RE: AMENDED MACQUARIE UNIVERSITY DESIGN EXCELLENCE STRATEGY AND URBAN DESIGN GUIDELINES

This letter has been prepared to inform the Department of Planning and Environment (DPE) of the recent revisions to the Macquarie University Design Excellence Strategy and Urban Design Guidelines (the Guidelines), which are required, and form part of the Part 3A Macquarie University Concept Plan (MP06\_0016).

*Figure 1 Excerpt of Previous and Revised Guidelines for Lot A01 and Lot A06*

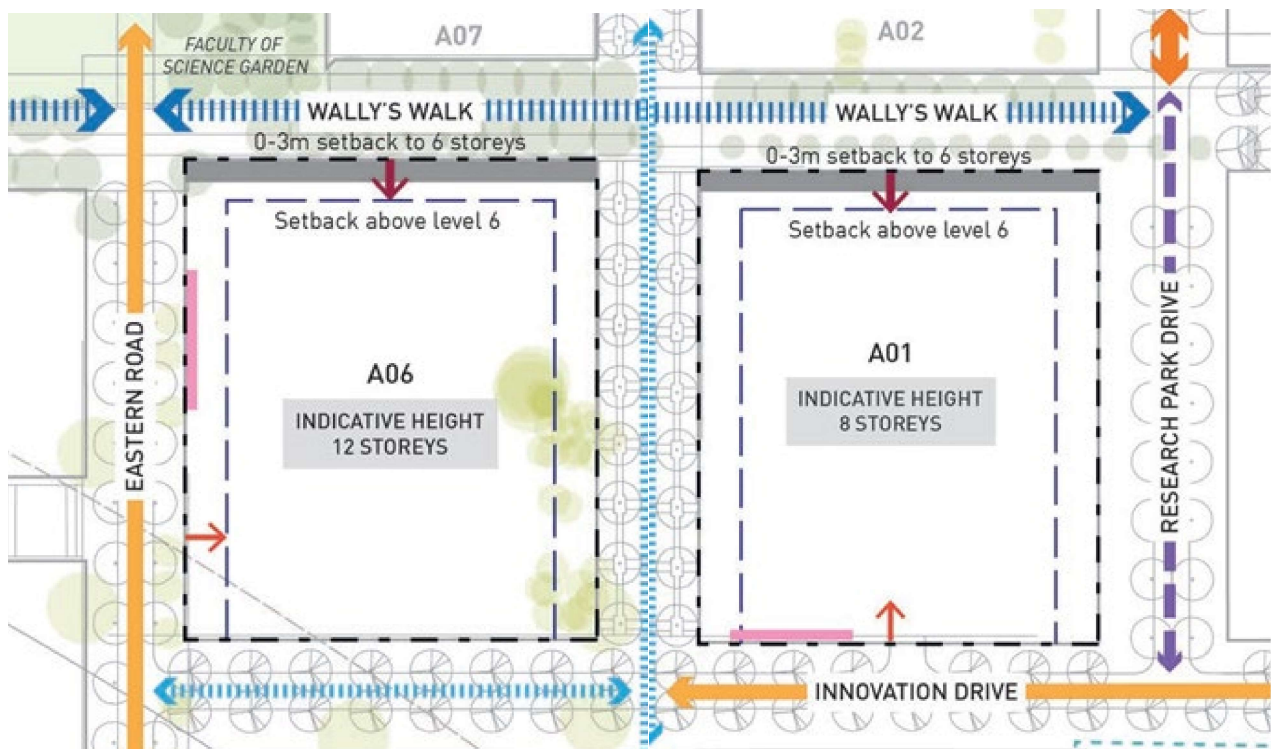
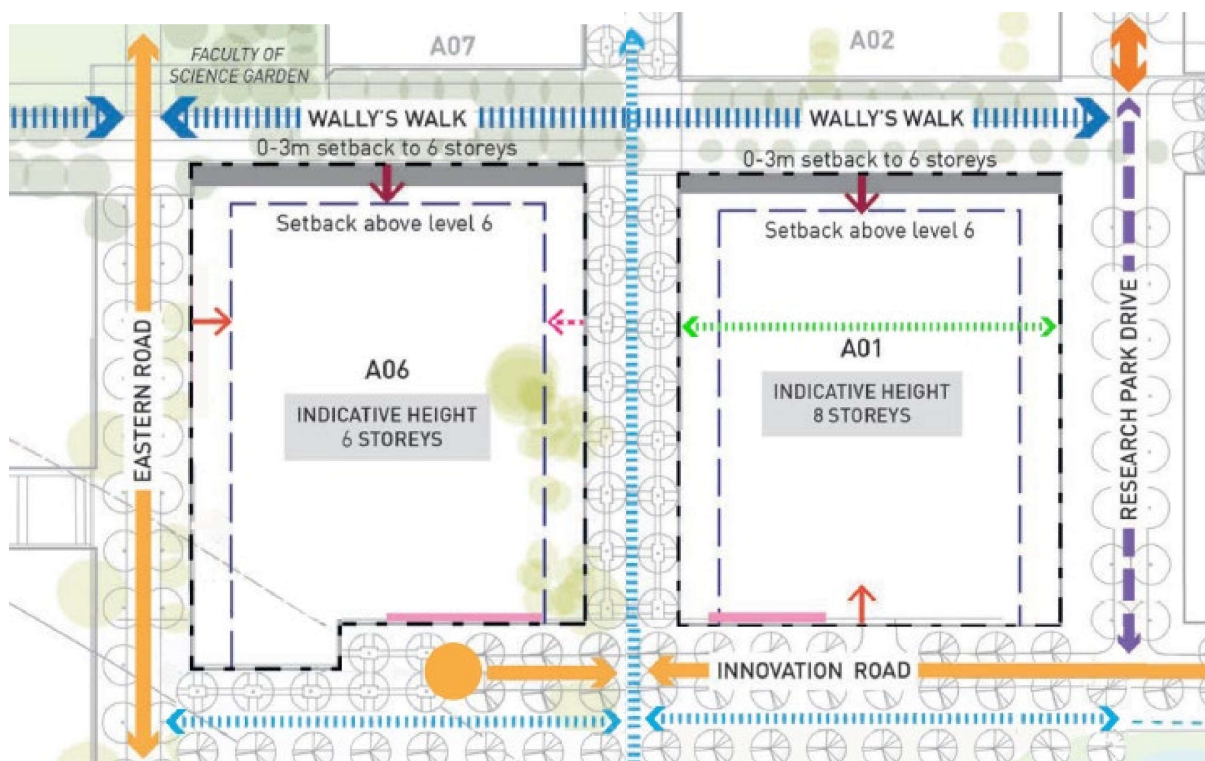
- Revisions to Lot A06 and A01, including the:
  - Realignment of the secondary pedestrian connection along the southern boundary further south to accommodate the extension of Innovation Drive as a service lane.
  - Introduction of a new internal east-west pedestrian link through the building.
